ASSESSMENT REPORT

ST VINCENTS PRIVATE HOSPITAL SSD 6840 MOD 1

Figure 3: Approved and Proposed Victoria Street Elevation

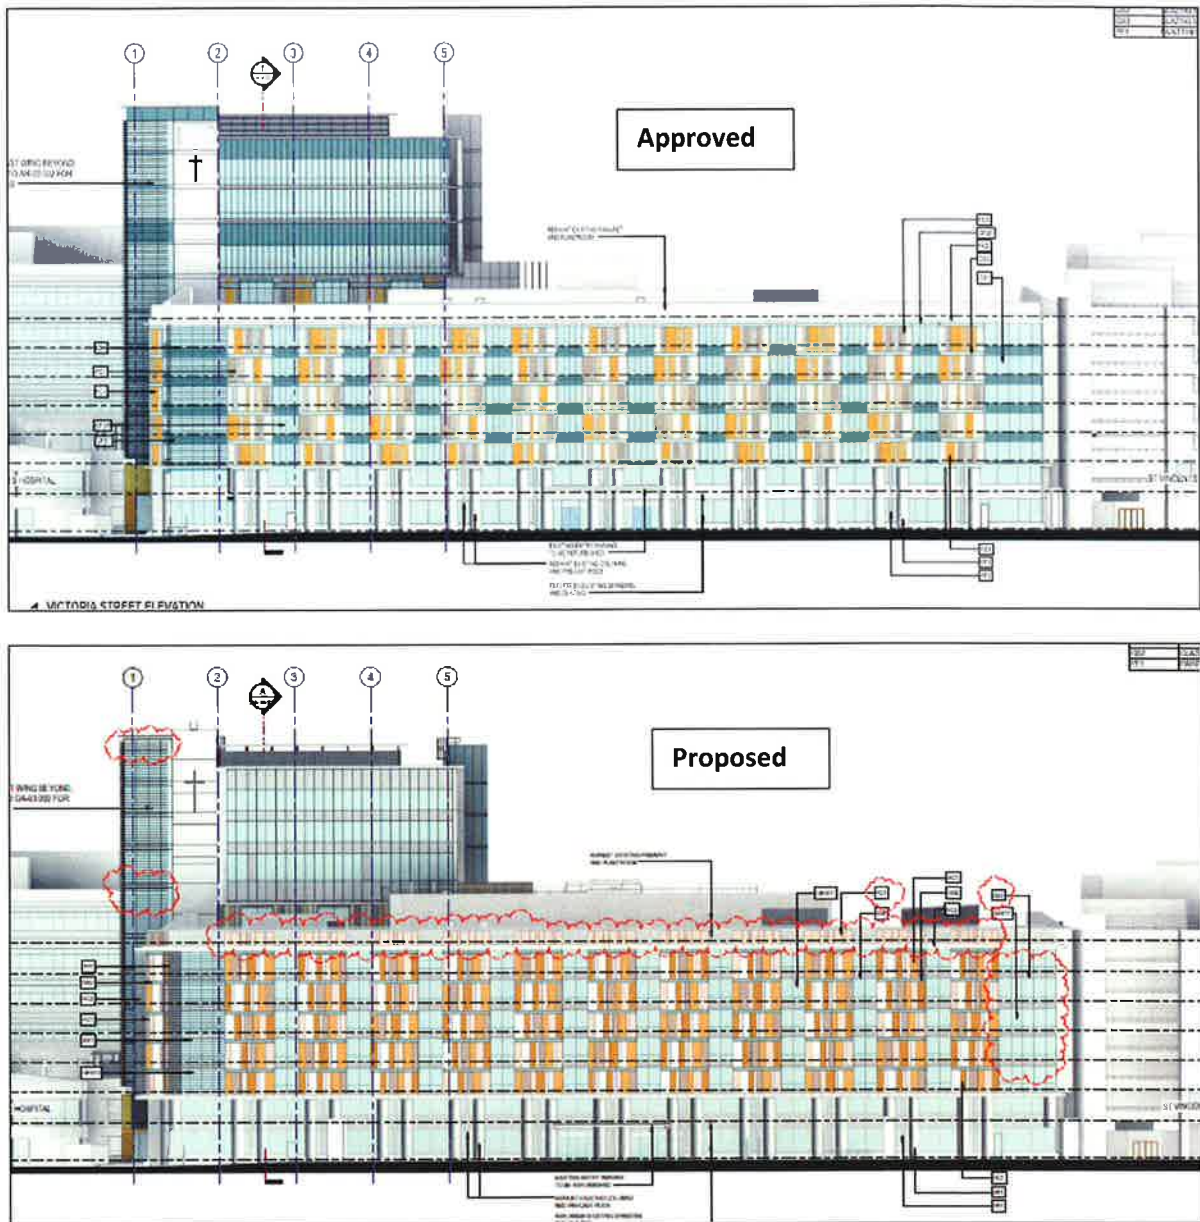
High Rise Building	
<i>External</i>	<p><i>Victoria Street Elevation</i></p> <ul style="list-style-type: none"> vertical extensions to the ensuites at the upper level; additional sun shading at the southern end;
<i>Internal</i>	<ul style="list-style-type: none"> increase in the size of ensuites at the northern end; reconfiguration of the internal layout to incorporate additional plant and storage rooms at Level 2; minor reconfiguration of the internal layout at Level 4; infill the existing void at Level 5; increase the size of the ensuites to the north elevation of the high rise wing at Levels 6 to 11; increase the hoist size serving Levels 5 to 8; increase in the extent of stairs at Levels 8 to 15; inclusion of additional plant on roof of the low rise building.
Low Rise Building	
<i>External</i>	<p>additional planter boxes along the eastern elevation at Level 7; and</p> <ul style="list-style-type: none"> new plant room on the roof.

Issue	Consideration	Recommendation
<i>Streetscape/ Built Form</i>	<ul style="list-style-type: none">• The proposal involves minor changes to the built form of the approved development.• The key changes visible from the public domain include:<ul style="list-style-type: none">– vertical extensions to upper level ensuites and the introduction of vertical shading at the southern end of the building facing Victoria Street; and– an increase in the extent of the spandrel panels on the east, south and west elevations and revised vertical sun shading devices on these elevations to allow for improved access to views.• In terms of visual impacts, the proposed changes are minor	No additional conditions or amendments are necessary.

<p>and do not change the overall appearance of the approved development.</p> <ul style="list-style-type: none"> Importantly, the external changes to the more prominent building facade facing Victoria Street would barely be discernible in the context of the entire development, and would not materially change the appearance of the building within the streetscape. The proposed external modifications would not have an adverse impact upon heritage items located within proximity of the site or the adjacent heritage conservation areas in Darlinghurst. Council has advised that the proposal is generally acceptable in terms of the external façade amendments. The Department is satisfied that the proposal would not result in any unacceptable adverse built form or visual impacts on the surrounding area. 	
<i>Building Height</i>	<ul style="list-style-type: none"> Proposed changes to the floor heights at Levels 13 to 15 result in a reduction of overall building height by 600 mm. The lift overrun in the north-eastern section of the East Wing building will also be reduced in height by 300 mm. The changes in floor to floor heights (Levels 13 and 14 would each be reduced by 300 mm), are considered minor and would not affect the functionality of the building. The levels would retain a floor to floor height of 3300 mm, which is considered adequate for consulting rooms. The Department is satisfied that the proposed changes are minor and the modification would not result in any notable change to the overall built form of the development. 	No additional conditions or amendments are necessary.
